**CITY OF MERIDIAN
FINDINGS OF FACT, CONCLUSIONS OF LAW
AND
DECISION & ORDER**

In the Matter of the Request for Conditional Use Permit for a Multi-Family Development Consisting of 472 Apartment Units in Two (2) 5-Story Buildings on 9.95-Acres of Land in the C-G (General Retail and Service Commercial) Zoning District for Records Apartments, Located at the Northeast Corner of N. Records Way and E. Franklin Rd., by Brighton Corporation.

Case No(s). H-2022-0008

STAFF REPORT COMMUNITY DEVELOPMENT DEPARTMENT

A. Site Plan (date: 4/20/2022 4/5/2022) & Rendering – Revised

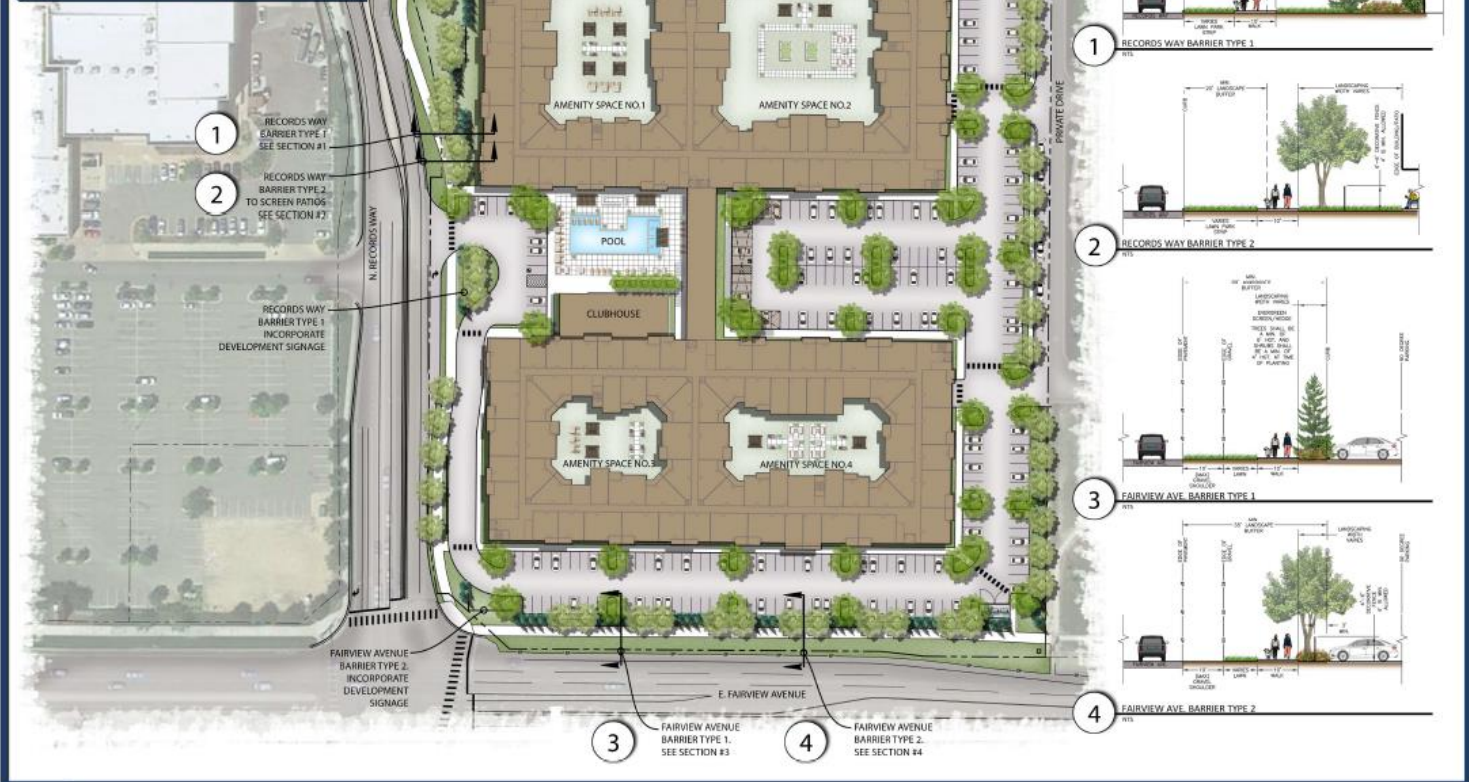
for the clubhouse for a total of 822 spaces with at least 388 of those in a covered carport or garage. A total of 815 spaces are proposed with 477 of those covered, which is seven (7) fewer than the minimum required. If the number of units are reduced to a maximum of 40 units per acre (gross) as recommended, this will reduce the number of required parking spaces which should then meet UDC standards. If the Commission approves the proposed density (47.4 units/acre), a minimum of seven (7) additional spaces shall be provided on this site and depicted on a revised site/landscape plan submitted prior to the Commission's action on this application; or, the number of 2- or 3-bedroom units could be reduced to reduce the parking requirement.

Access: Access is proposed from N. Records Way, a collector street, at the west boundary of the site; and from an existing driveway via E. Elden Gray St., a local street, along the east boundary of the site. **If one doesn't already exist, a cross-access easement shall be granted to the adjacent property to the east (CarMax) for use of the portion of the driveway that lies on this site. A recorded copy of the easement shall be submitted with the first Certificate of Zoning Compliance application.**

Where access to a local street is available, the UDC ([11-3A-3A.1](#)) requires the site circulation to be to be reconfigured to take access from such local street. This standard applies unless otherwise waived by City Council. Therefore, the access via N. Records Ave. is not allowed and shall be removed from the site/landscape plan. The Applicant may request City Council approval of a waiver of this provision as allowed in UDC 11-3A-3 through submittal of an application for City Council Review of the Commission's decision on this matter. *Note: ACHD has approved this access with the requirement of a right-turn lane.*

Landscaping is required within parking lots in accord with the standards listed in UDC 11-3B-8C. **The three (3) "diamond" planter islands between the north & south portions of the building do not meet the standards in UDC 11-3B-8C.2, which require planters to contain a minimum of 50 square feet and run the length of the parking space; the site/landscape plan should be revised accordingly. Where bumpers overhang perimeter landscaping in parking areas, the parking stall dimensions may be reduced 2' in length if 2' is added to the width of the landscaped area planted in groundcover; otherwise, wheel stops should be provided to prevent vehicle overhang. The perimeter buffers/parking along the south and east boundaries of the site should be revised to comply with this standard.**

- e. Remove the three (3) “diamond” planter islands between the north & south portions of the building and replace them with planter islands that comply with the standards in UDC [11-3B-8C.2](#).

- i. Depict off-street vehicle parking and bicycle parking spaces in accord with the standards listed in UDC [11-3C-6](#) (i.e. currently, a minimum of 822 off-street vehicle parking spaces are required with at least 388 of those in a covered carport or garage for the multi-family units, guest and clubhouse; and a minimum of 30 bicycle parking spaces are required depending on how many vehicle parking spaces are provided – these numbers will change if fewer units are provided as recommended).

- k. Remove the access driveway via N. Records Way in accord with UDC 11-3A-3A.1, unless otherwise waived by City Council. *The Applicant plans to request a waiver from City Council to this standard.*

B. Landscape Plan (dated: 1/20/22, 4/5/22) – Revised

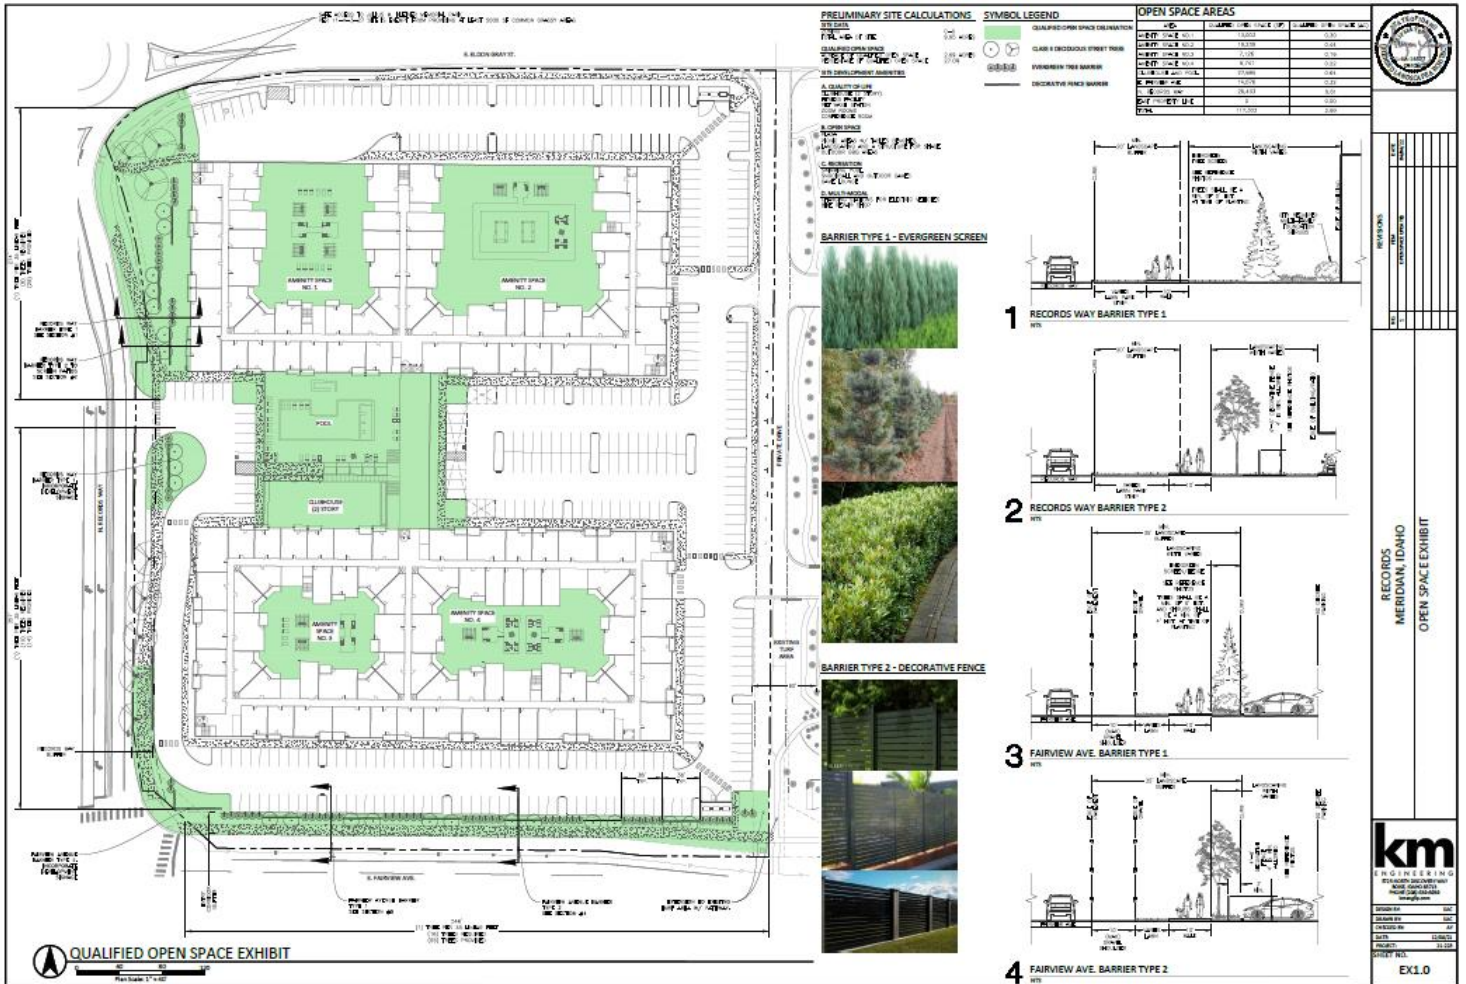
Landscaped street buffers are required to be provided as follows: a 35-foot wide street buffer is required along E. Fairview Ave., an entryway corridor; a 20-foot wide buffer is required along N. Records Way, a collector street; and a 10-foot wide buffer is required along E. Elden Gray St., a local street, per UDC Table 11-2B-3 and landscaped per the standards listed in UDC [11-3B-7C.3](#). **Some portions of the buffers along Records and Fairview are below the required widths and should be revised. All buffers are required to be planted with a variety of trees, shrubs, lawn or other vegetative groundcover and designed to elicit design principles including rhythm, repetition, balance and focal elements per the recently updated specifications; the landscape plan shall be revised accordingly.**

Landscaping is required to be provided along all pathways per the standards listed in UDC [11-3B-12C](#), which require a *mix* of trees, shrubs, lawn and/or other vegetative groundcover. **Shrubs should be added to the landscape plan in accord with this standard where none are depicted.**

The minimum width of parkways planted with Class II trees is 8-feet; the planter width may be reduced to 6-feet if there are root barriers that meet the standards in UDC [11-3A-17E](#). The site/landscape plans shall be revised accordingly.

- f. Shrubs shall be added to the landscape strips along pathways where none currently exist in order to contribute to the *mix* of landscaping required by UDC [11-3B-12C.2](#).

- l. The minimum width of parkways planted with Class II trees is 8-feet; the planter width may be reduced to 6-feet if there are root barriers that meet the standards in UDC 11-3A-17E.
